TRANS/WP.29/GRSP/2000/15  
15 September 2000

PROPOSAL FOR DRAFT AMENDMENTS TO REGULATION No. 44  
(Child restraints)

Transmitted by the Expert from the Netherlands

Figure 1  
Arrangement for testing a forward-facing device"

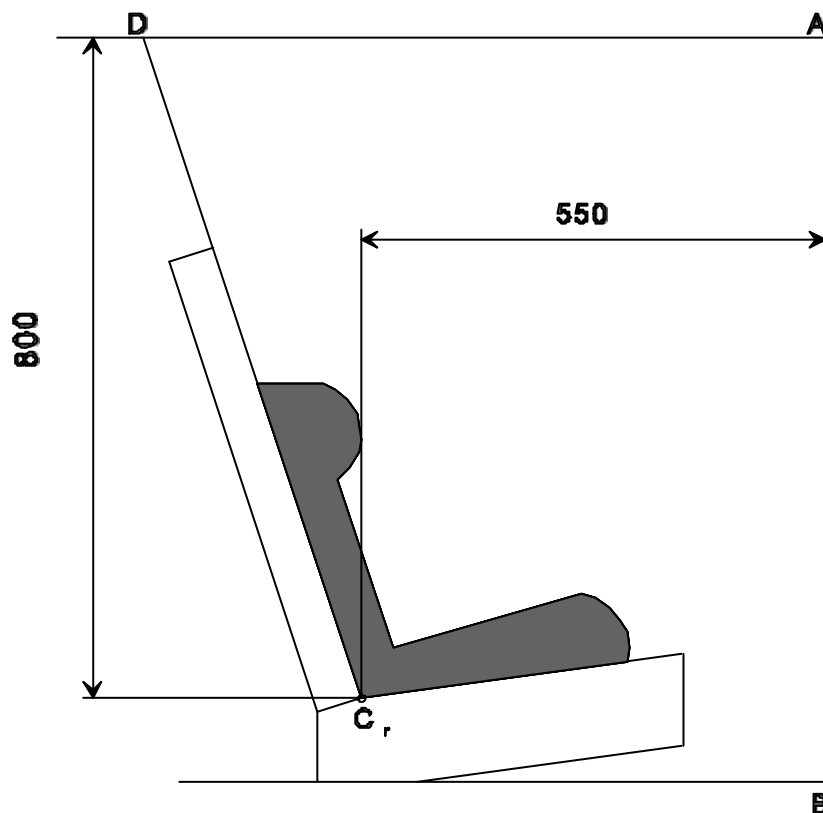
"7.1.4.4.1.1. Forward facing child restraints: the head of the manikin shall not pass beyond the planes BA and DA as defined in Figure 1 below. *This shall be judged up to the moment that the manikin has come to a definitive standstill.*

**Figure 2:**  
**Arrangement for testing**  
**a rearward-facing device**

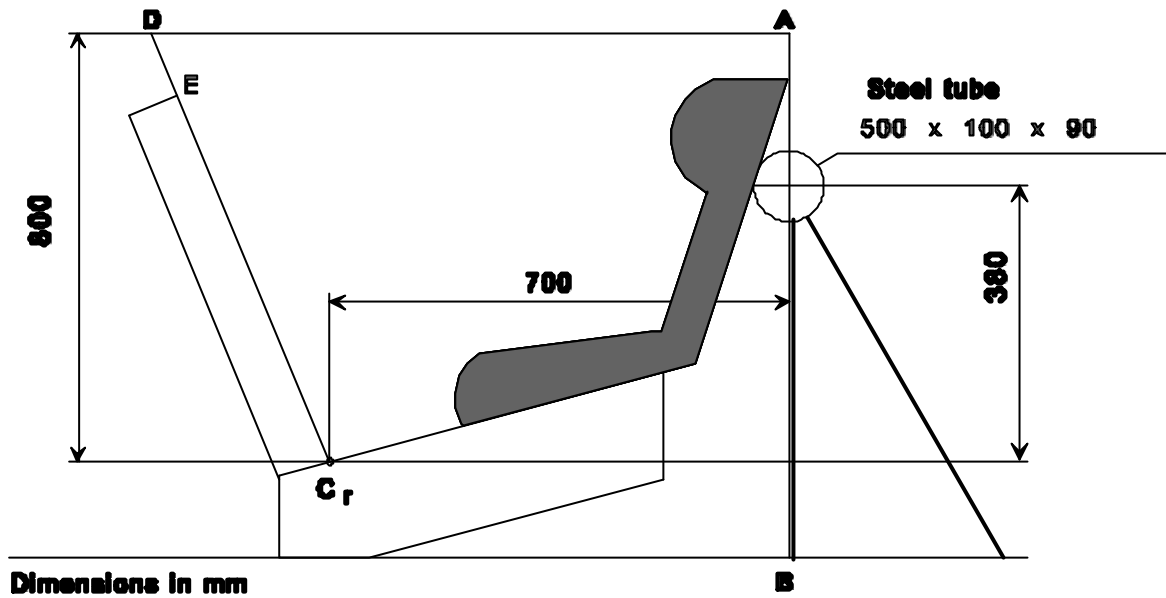
"7.1.4.4.1.2.1. Child restraints supported by dashboard: the head of the manikin shall not pass beyond the planes AD and DCr, as defined in Figure 2 below. *This shall be judged up to the moment that the manikin has come to a definitive standstill.*

Figure 3

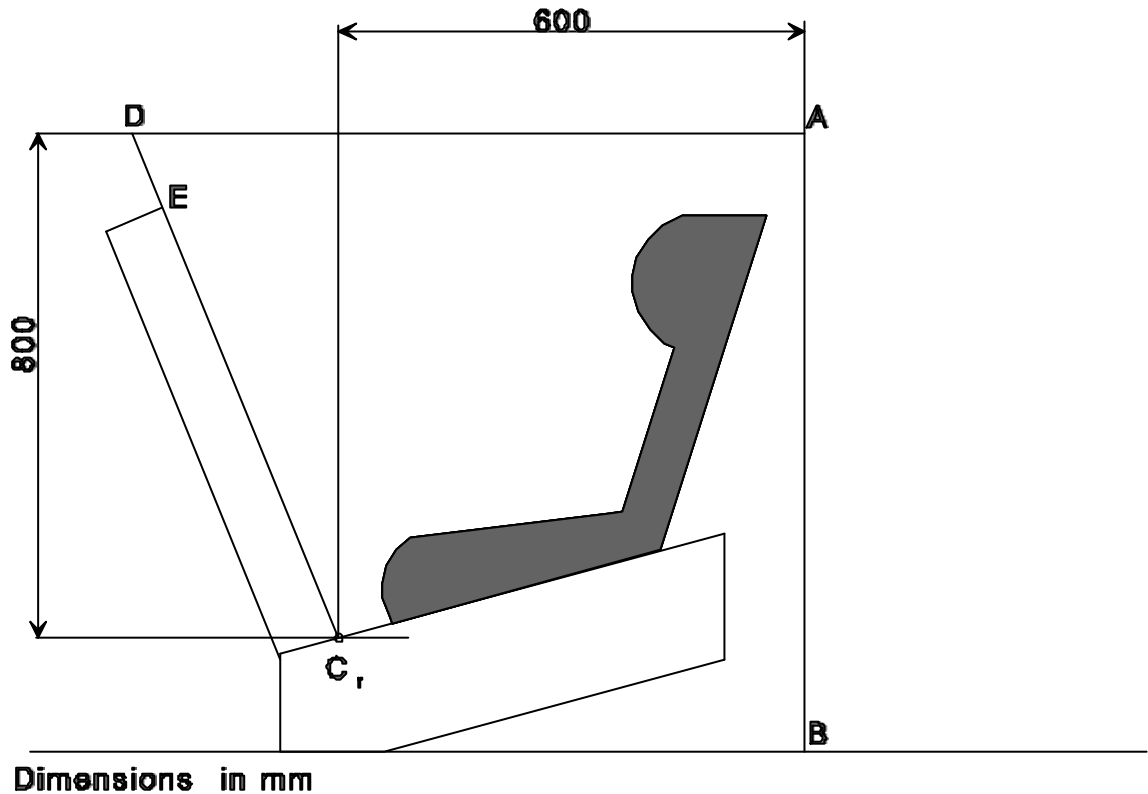
"7.1.4.4.1.2.2. Child restraints in group 0 not supported by the dashboard, and carrycots: the head of the manikin shall not pass the planes AB, AD and DE as shown in Figure 3 below. *This shall be judged up to the moment that the manikin has come to a definitive standstill.*
